City of Bristol
Zoning Commission

REGULAR MEETING - MONDAY, APRIL 8, 2024
6:00 P.M. - CITY HALL COUNCIL CHAMBERS
111 NORTH MAIN STREET, BRISTOL

AGENDA

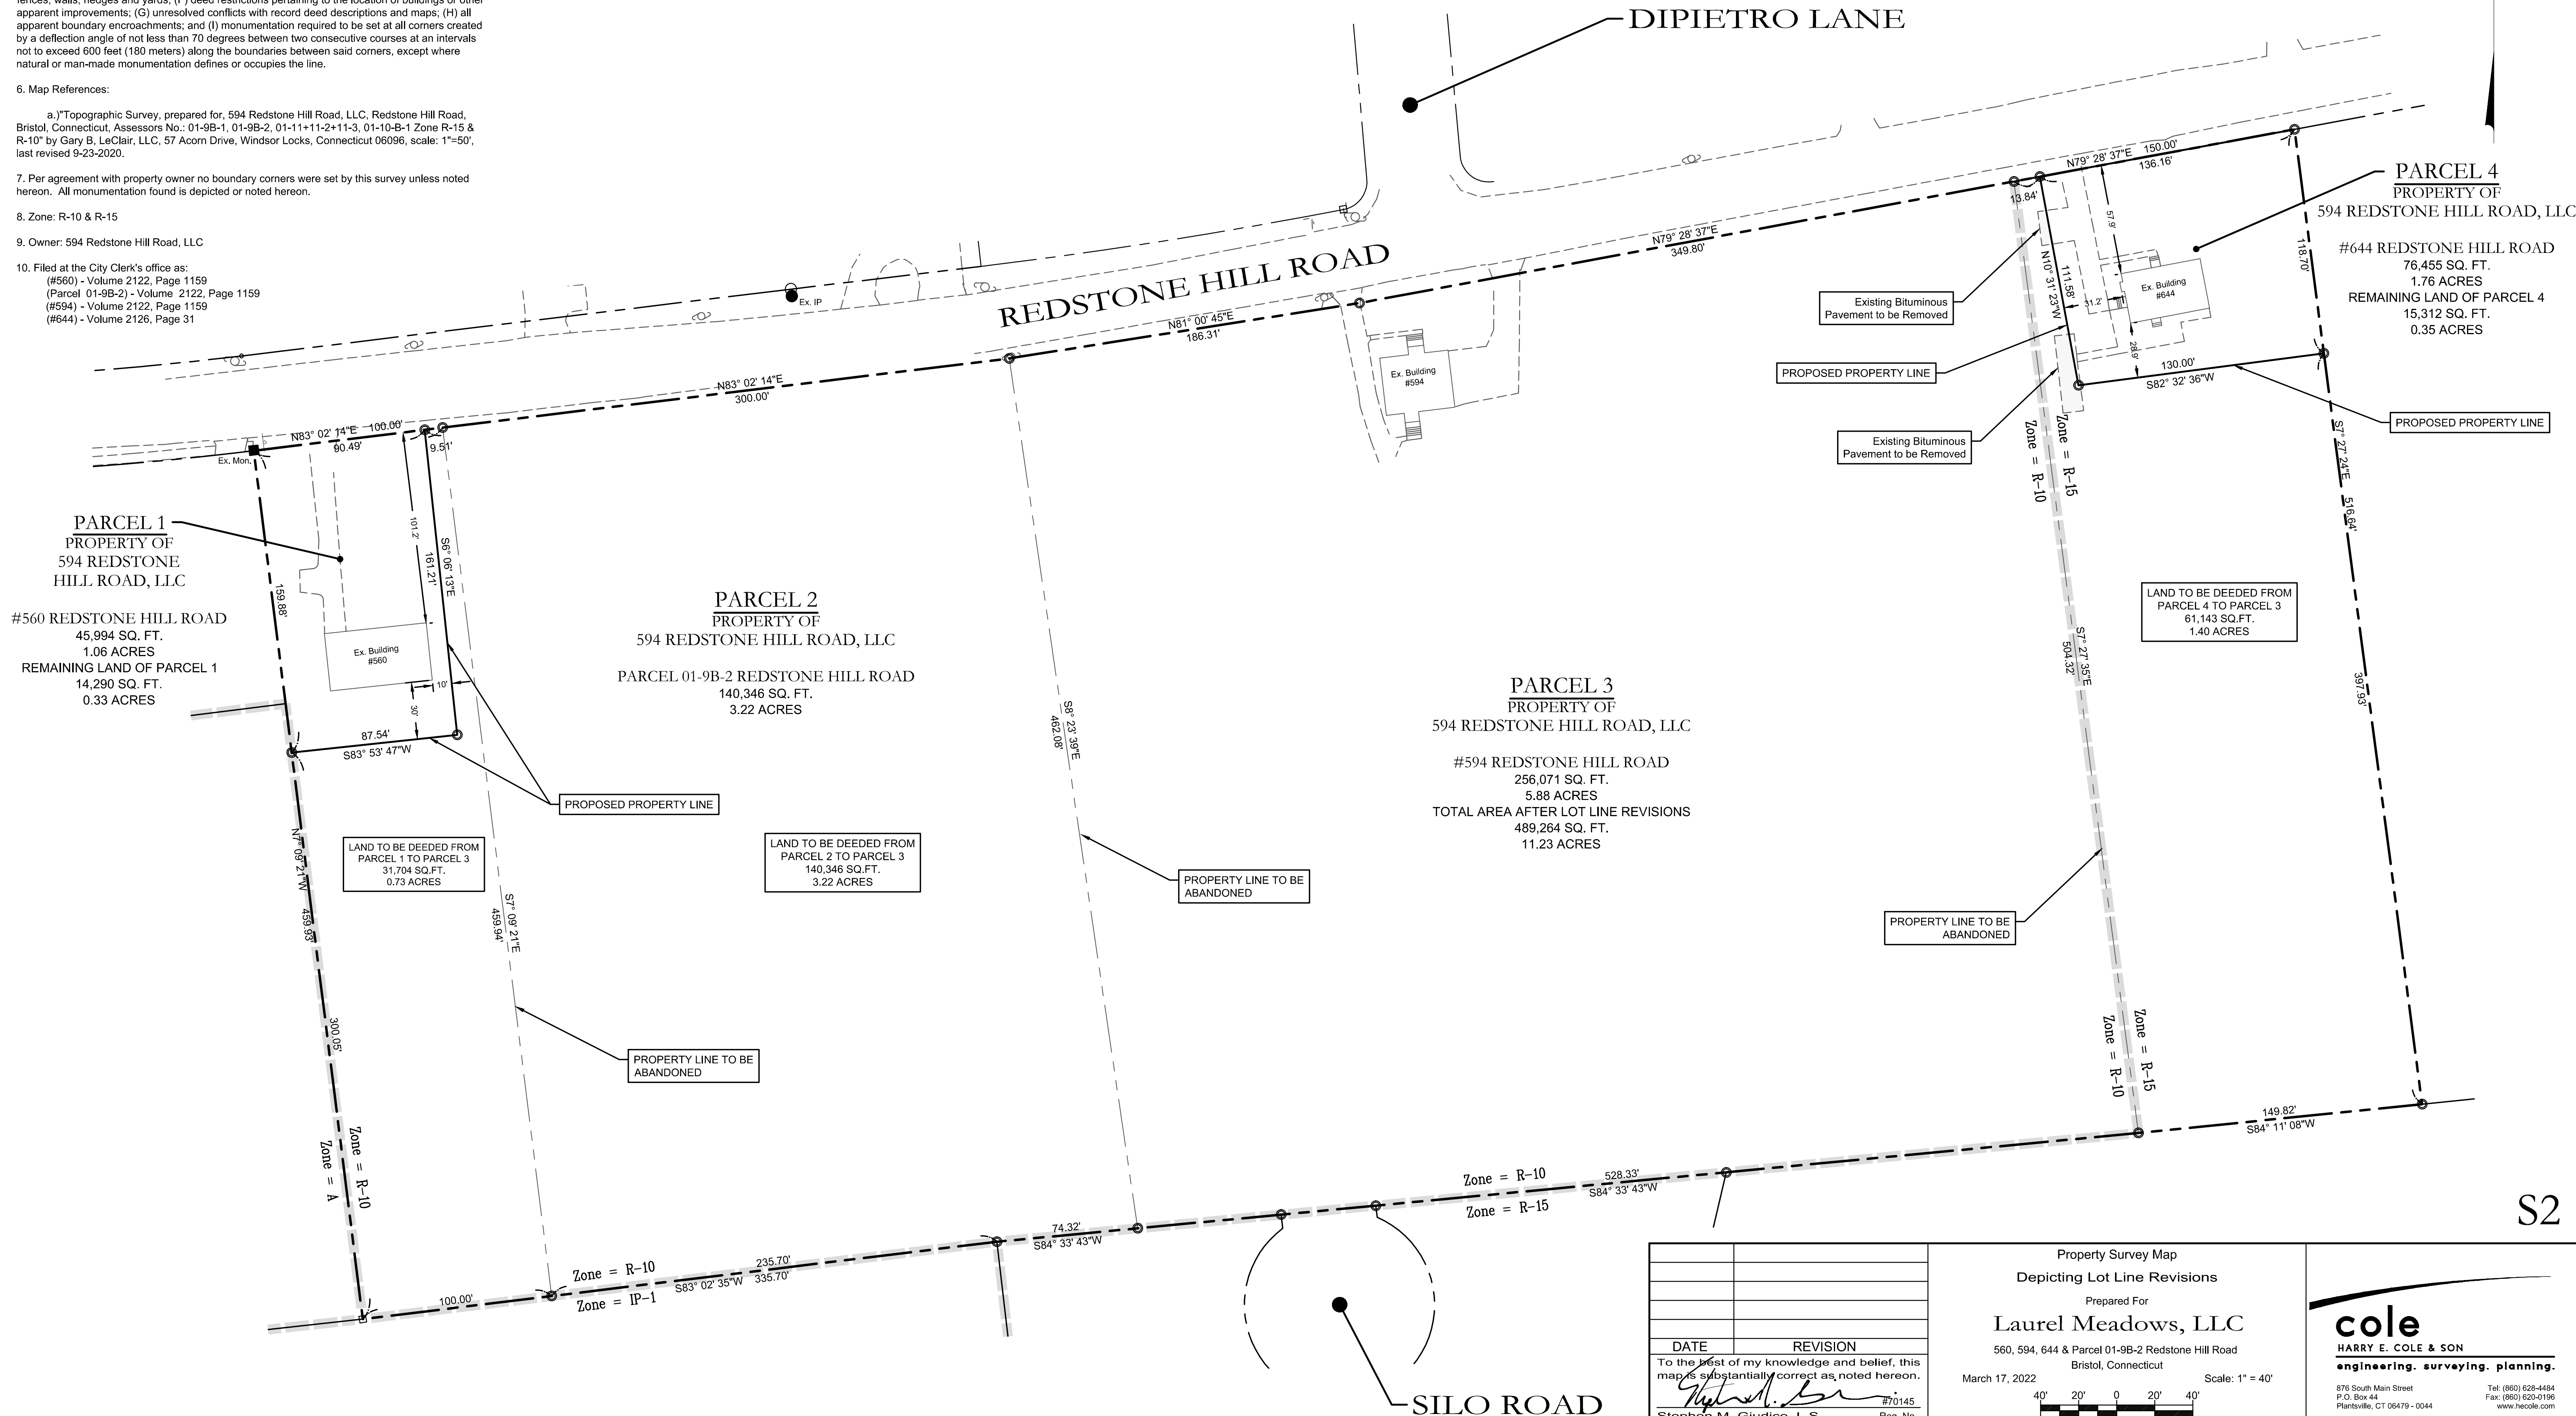
15. Revise R-15 zone lot frontage listed in zoning compliance chart.
16. Change “lot width” to “minimum lot frontage” on zoning compliance chart, Sheet S2.

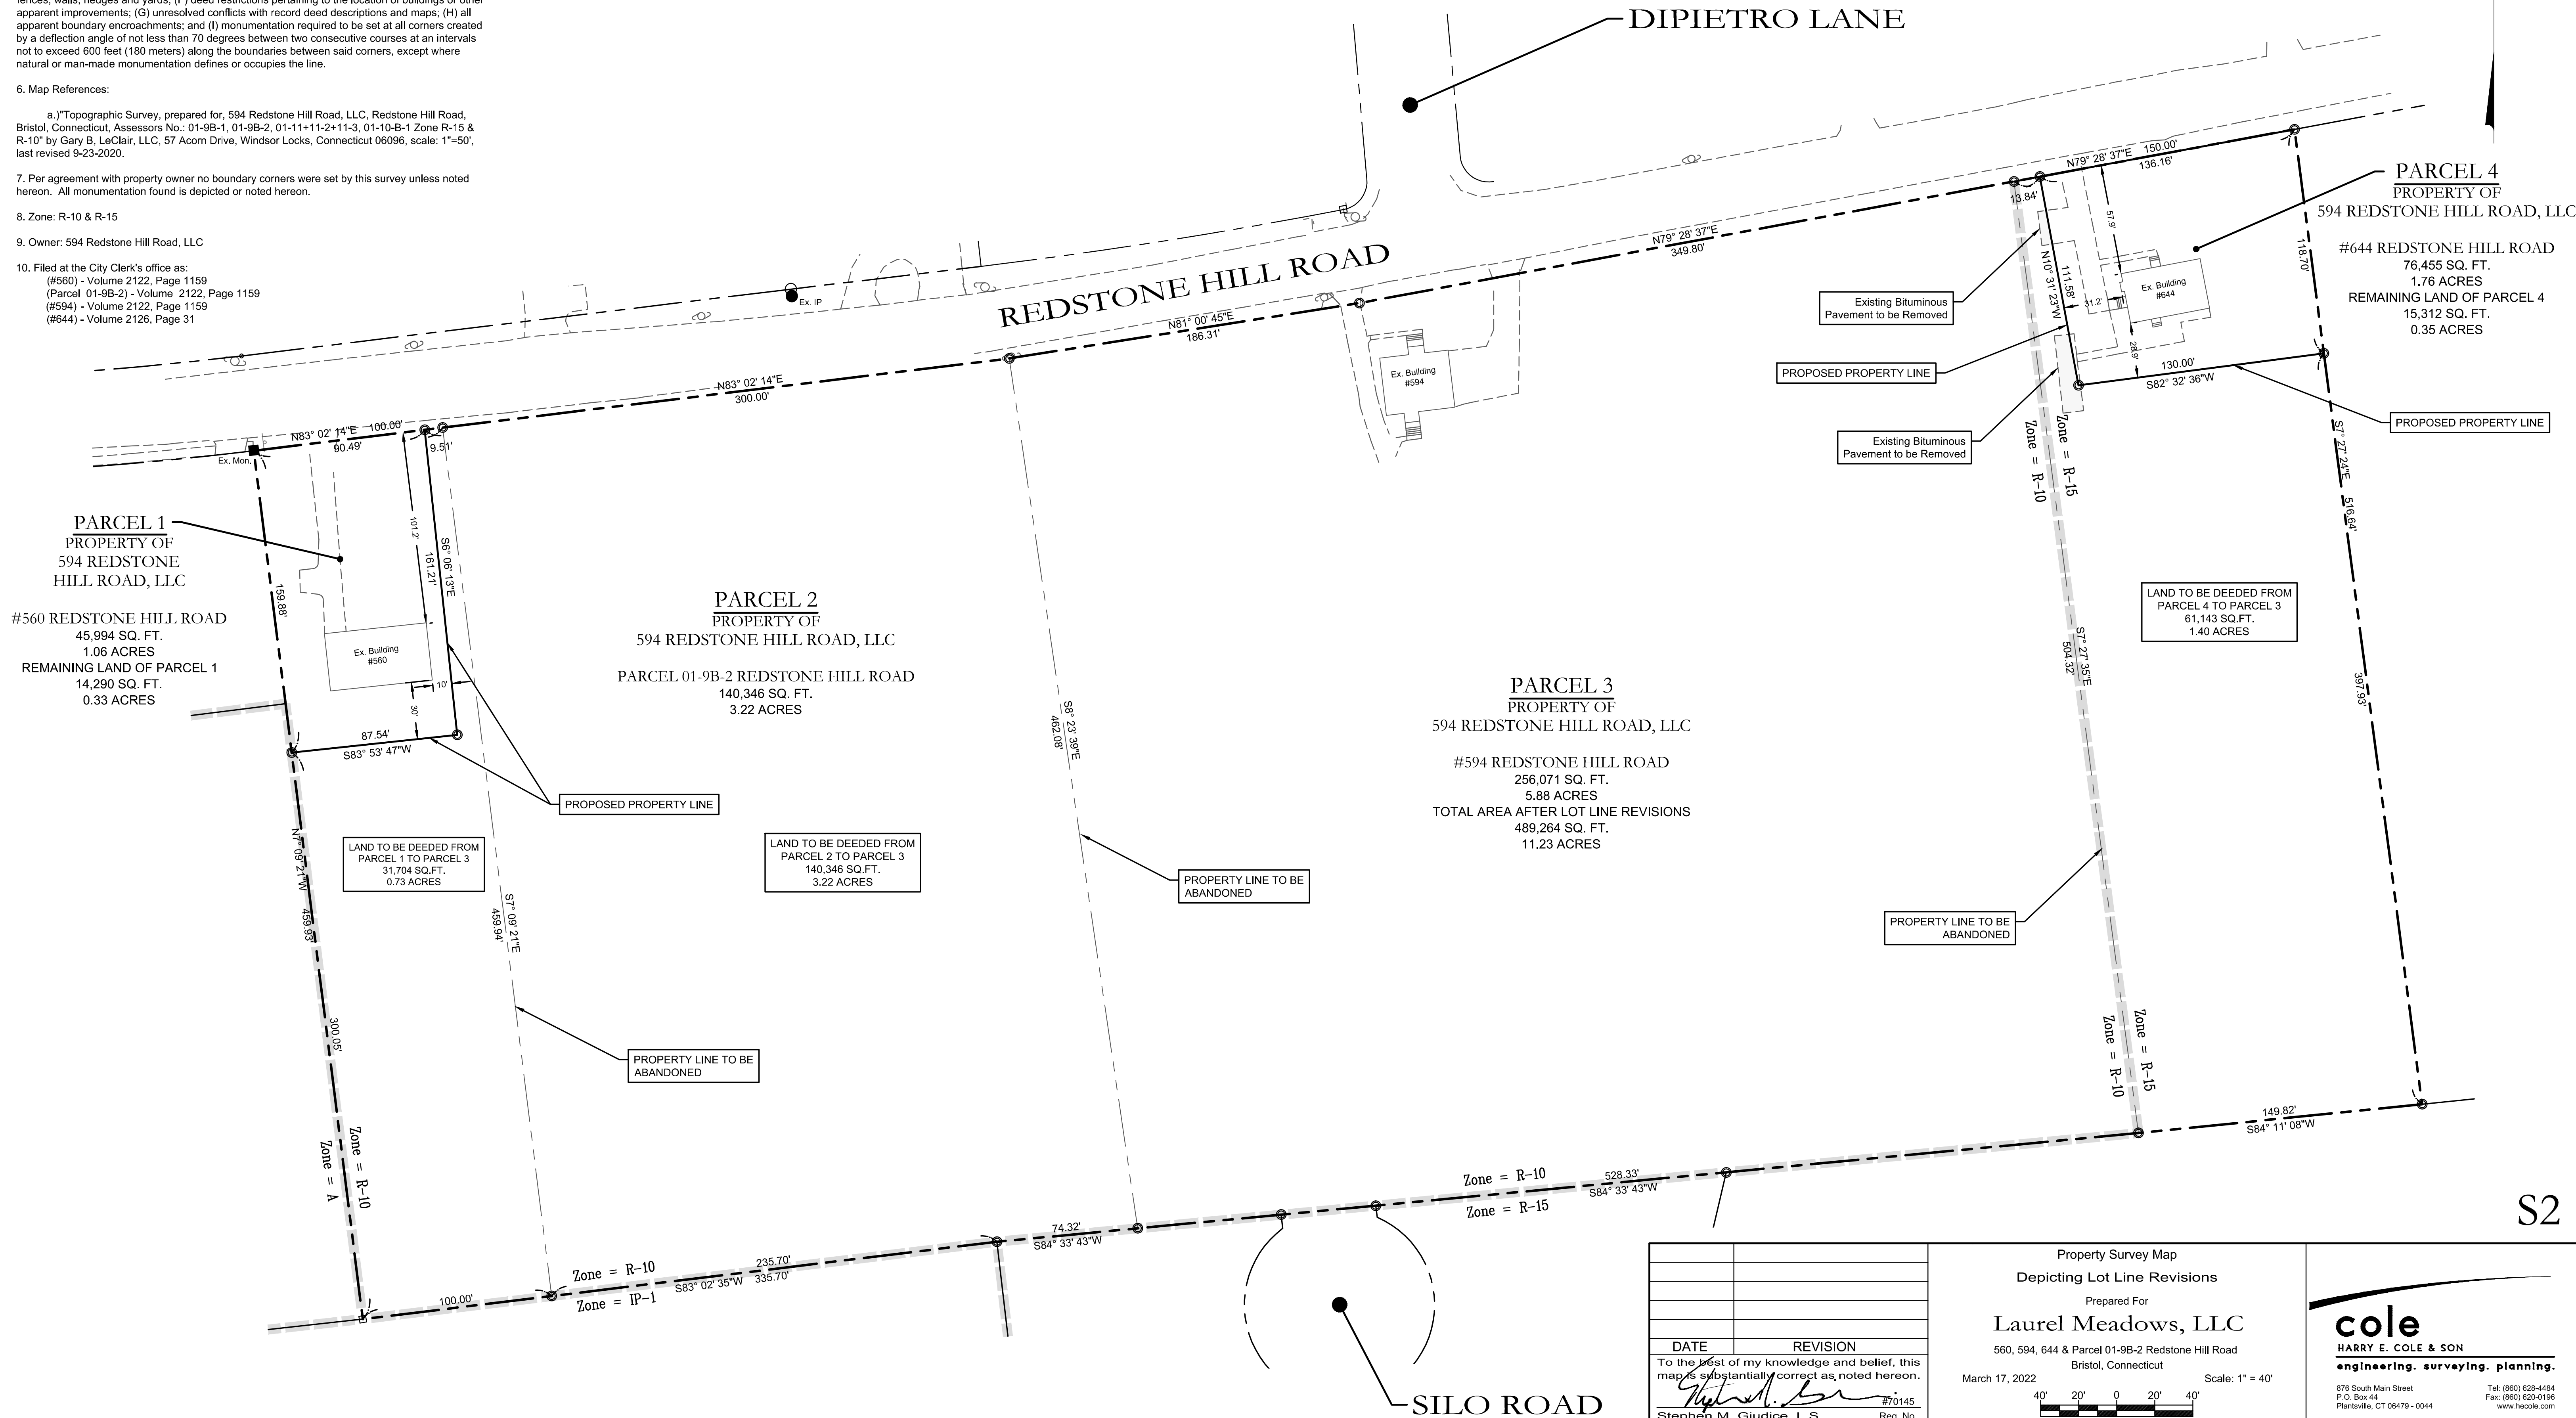
15. Revise R-15 zone lot frontage listed in zoning compliance chart.
16. Change “lot width” to “minimum lot frontage” on zoning compliance chart, Sheet S2.
